Our Case Number: ABP-317660-23

Re: Bus Connects Kimmage to City Centre core bus corridor scheme
Kimmage, Dublin

KIMMAGE TO CITY CENTRE CORE BUS CORRIDOR SCHEMELANDSCAPING AND URBAN REALM

BCIDD-ROT-ENV_LA-0011_ML_00-DR-LL-0005 Sheet 4 of 14 (general note to entire route)

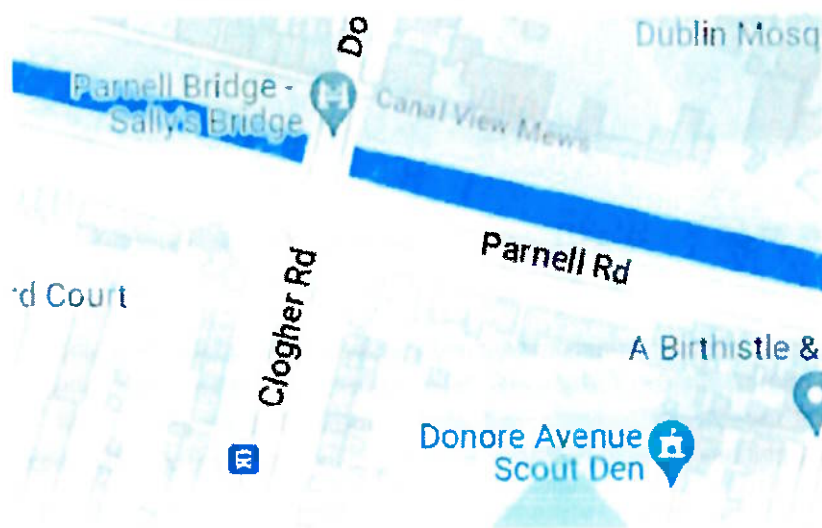
There are existing telephone / light / sign poles which are poorly located which prevent two way walking traffic due to minimum distance between poles & boundary wall to the footpath. Suggest survey carried out to determine locations to full layout (sheet 1 – 14) and correct amend within layouts.

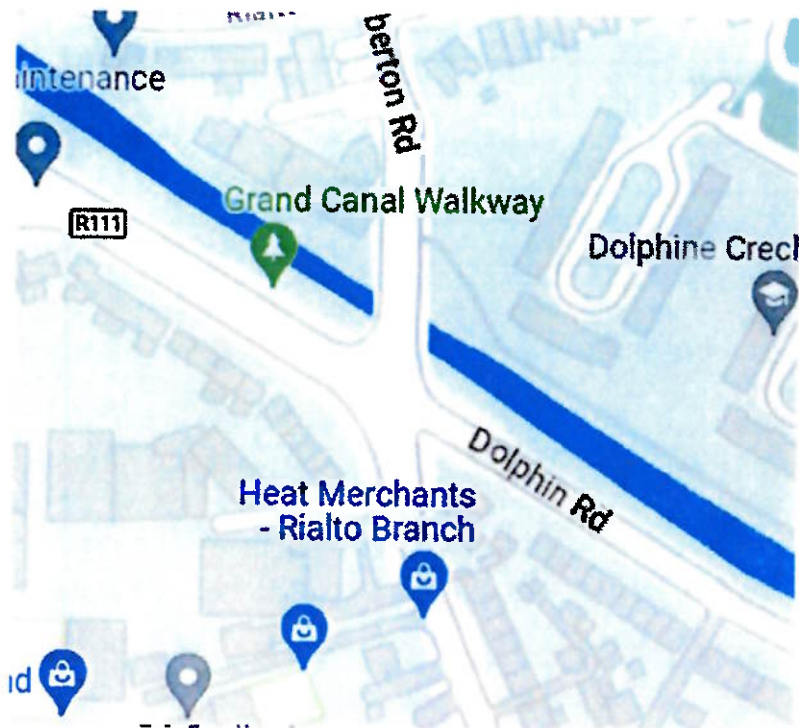
There are existing telephone / light / sign poles which are poorly located which prevent two way traffic due to minimum distance between poles & boundary wall to footpath. It is an particularly an issue when meeting with prams or wheelchairs The concrete foot paths have been shown as yellow indicating no amendment to locations. These poles should be repositioned while the improvement works are underway. Suggest survey carried out to determine locations to full layout (sheet 1 – 14) and correct amend within layouts. See below photo for example

There are existing telephone / light / sign poles which are poorly located which prevent two way walking traffic due to minimum distance between poles & boundary wall to the footpath. The concrete foot paths have been shown as yellow indicating no amendment to locations. This poles should be repositioned while the works are underway. These poles should be repositioned while the

Improvement works are underway. Suggest survey carried out to determine locations to full layout (sheet 1 – 14) and correct amend within layouts. See below photo for example.

BCIDD-ROT-ENV_LA-0011_ML_00-DR-LL-0003 Sheet 3 of 4

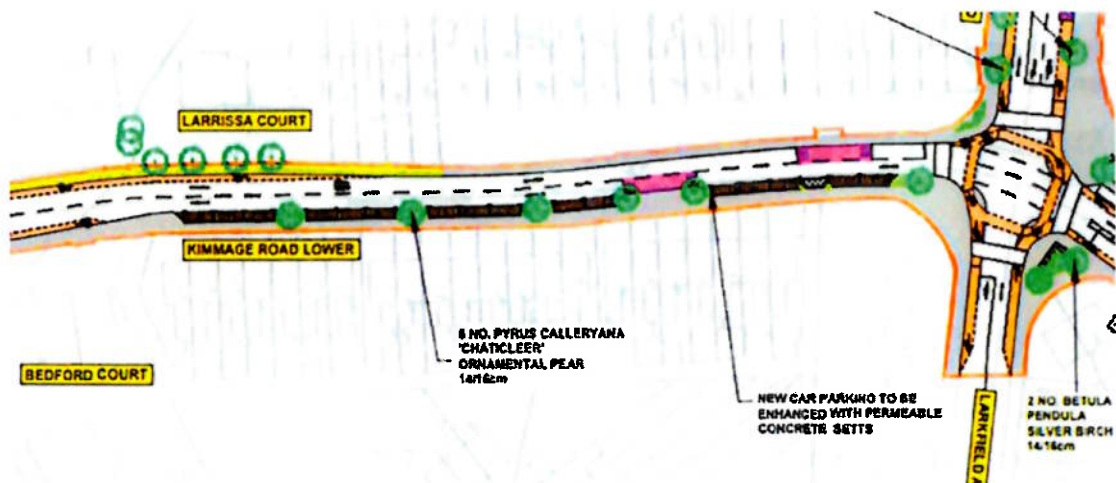
There are less tree provisions being provided to Lower Kimmage Road / Sundrive Rd road junction than was shown in the preferred route PDF issued previously. Suggest increasing.
